**SEMINOLE COUNTY GOVERNMENT  
AGENDA MEMORANDUM**

**SUBJECT:** Trails and Greenways Map Text Amendment

**DEPARTMENT:** Public Works      **DIVISION:** Engineering / Special Projects

# Seminole County, Florida Trails, Greenways, and Bikeways Master Plan

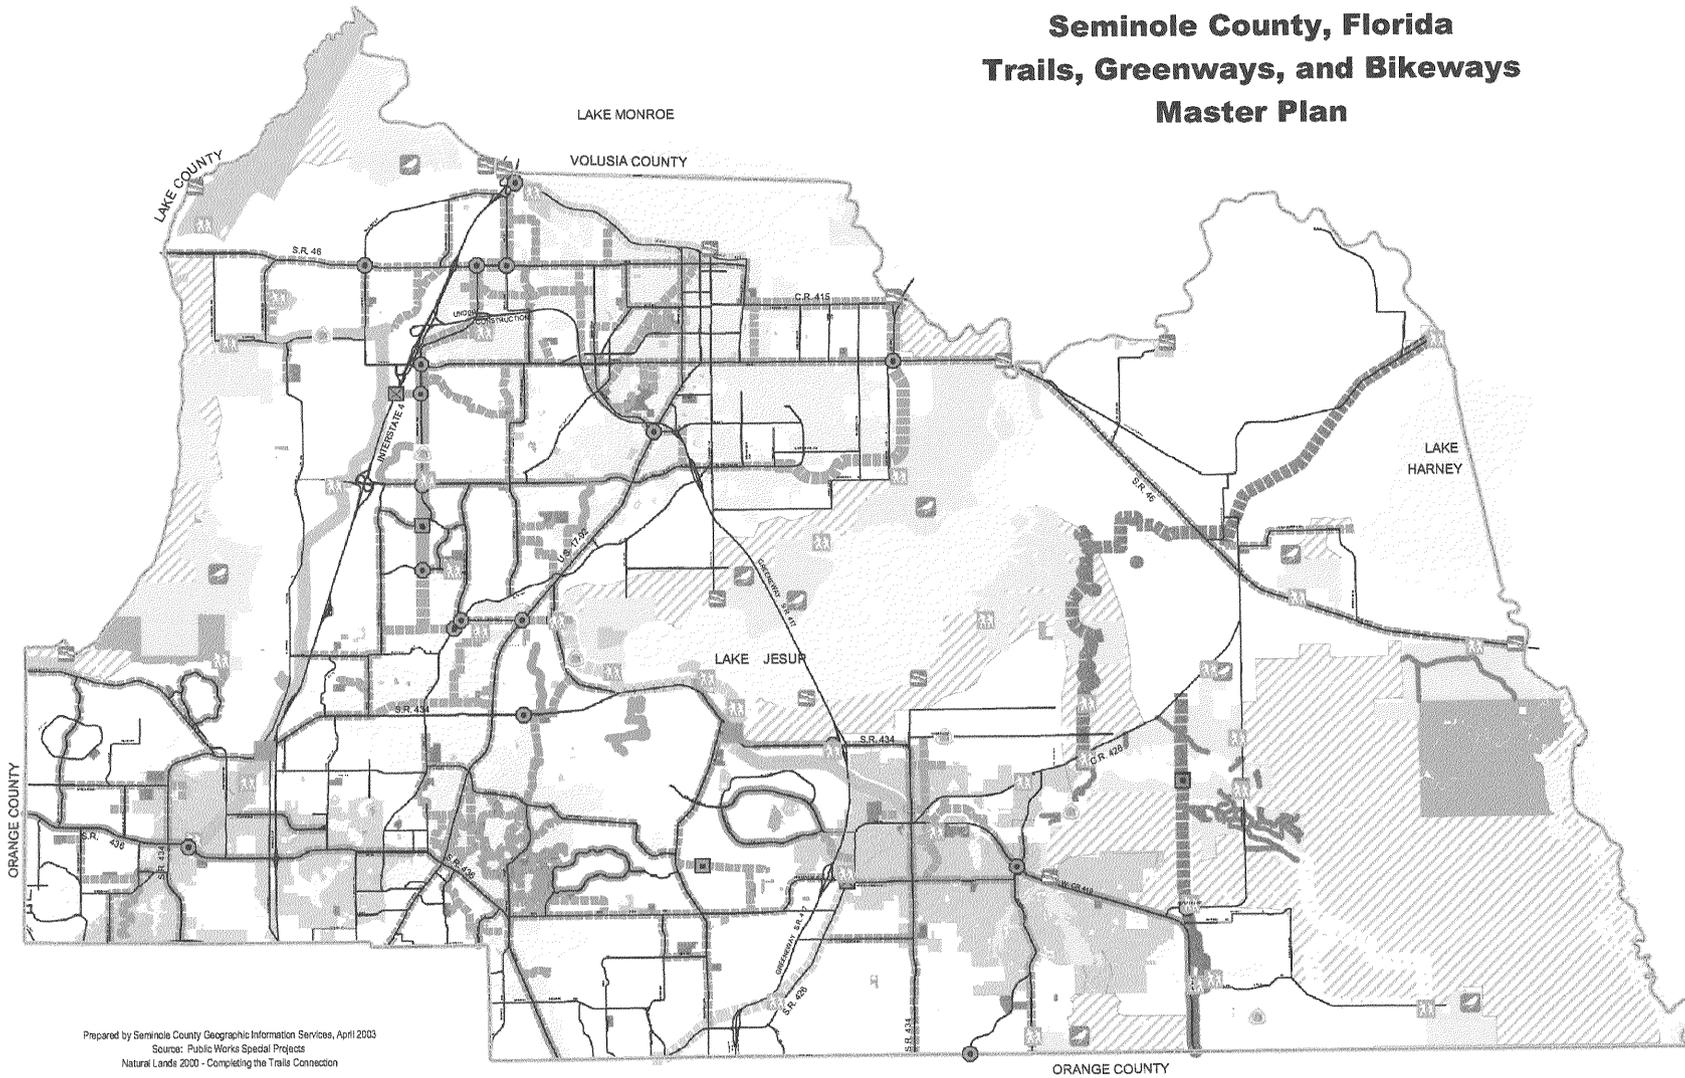
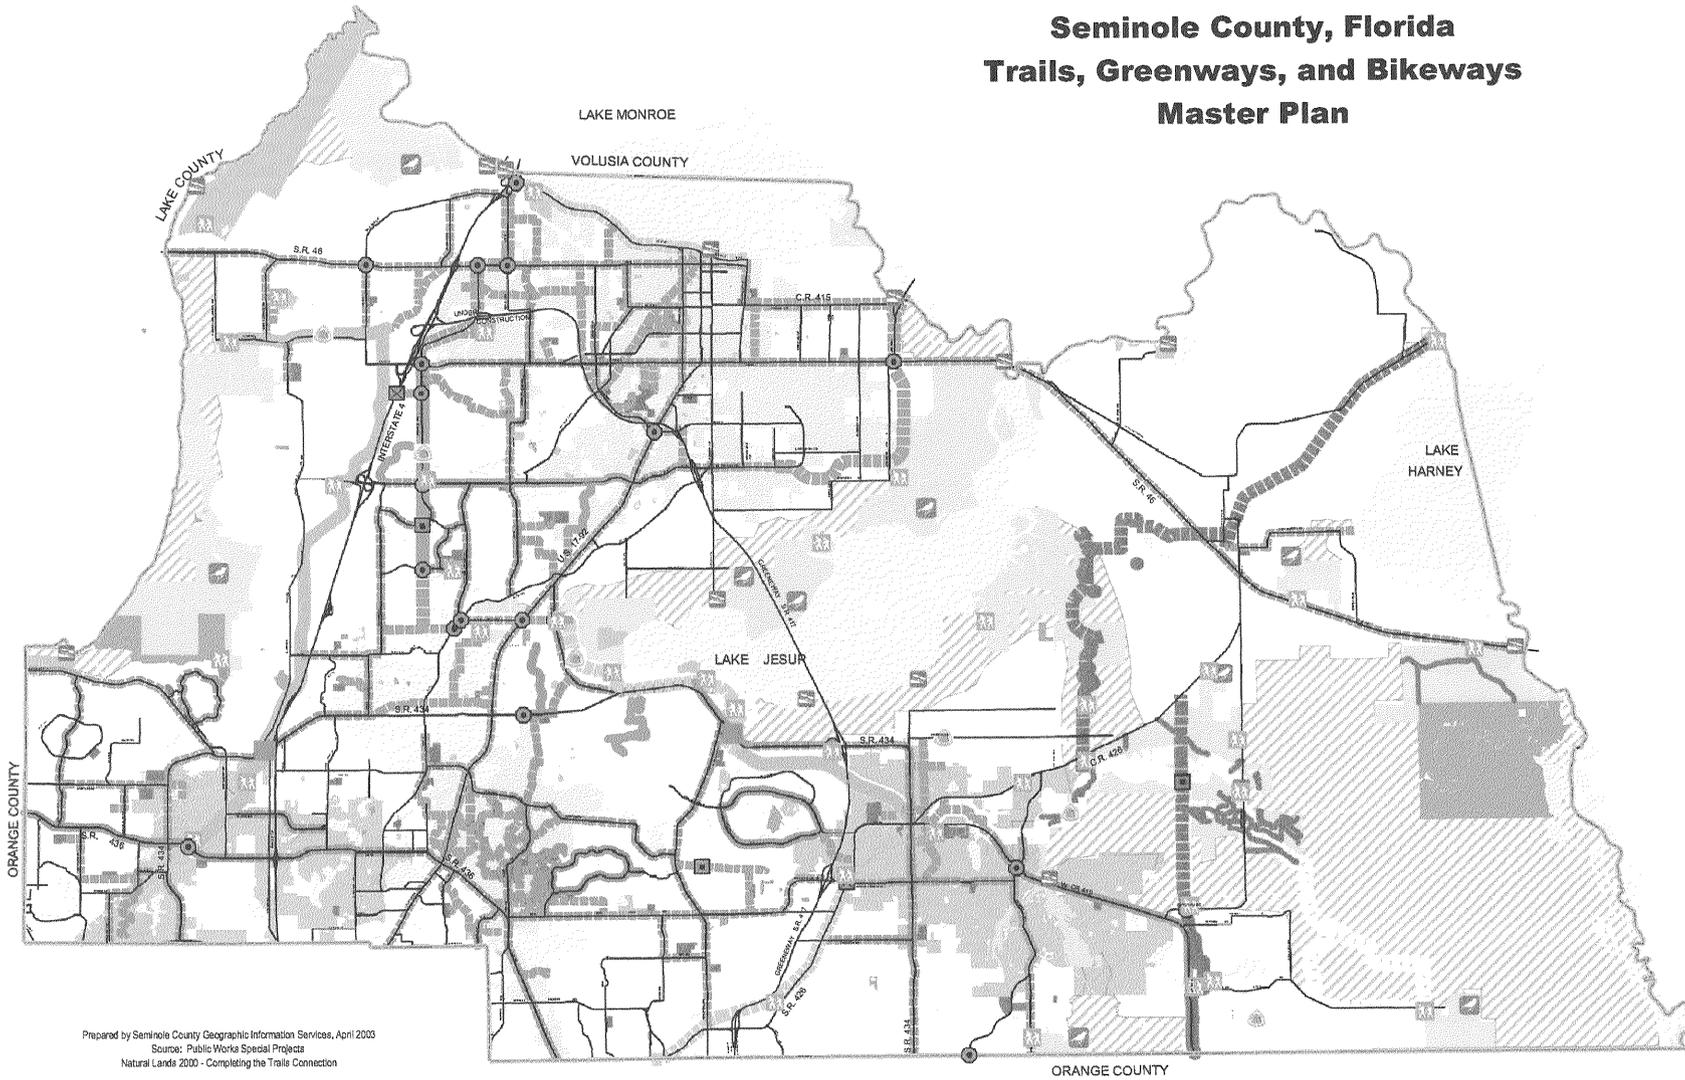
1. The Kewannee Trail alignment has been modified to show its southerly connection to SR 436.
2. A segment of the Flagler Trail south of SR 46 has been modified to show the current proposed route.

The Flagler Trail was previously classified as a Major Wilderness Trail with a “showcase trail” overlay. The overlay has been deleted.

1. A segment of minor trail along Sanford Avenue, south from East Lake Mary Boulevard to Lake Jesup, has been deleted.
2. A segment of minor trail along Orange Boulevard from Oregon Avenue to SR 46 has been deleted.
3. Deletion of a potential route along a power line right of way in the easternmost portion of the county.
4. Addition of a proposed minor trail from Geneva east to Lake Harney.
5. Addition to the “Trails and Greenways Linkages” plan of an existing minor trail along Primera Blvd.

1. Routes of power lines have been deleted.
2. City boundaries have been added.
3. The “keys” on the two maps have been modified to utilize the same symbols and trails classifications.

The LPA/P&Z voted 4-0 to recommend approval of the text amendment to the Board of County Commissioners with the recommendation that the north-south wilderness trail in the eastern portion of the County not be deleted from the maps.
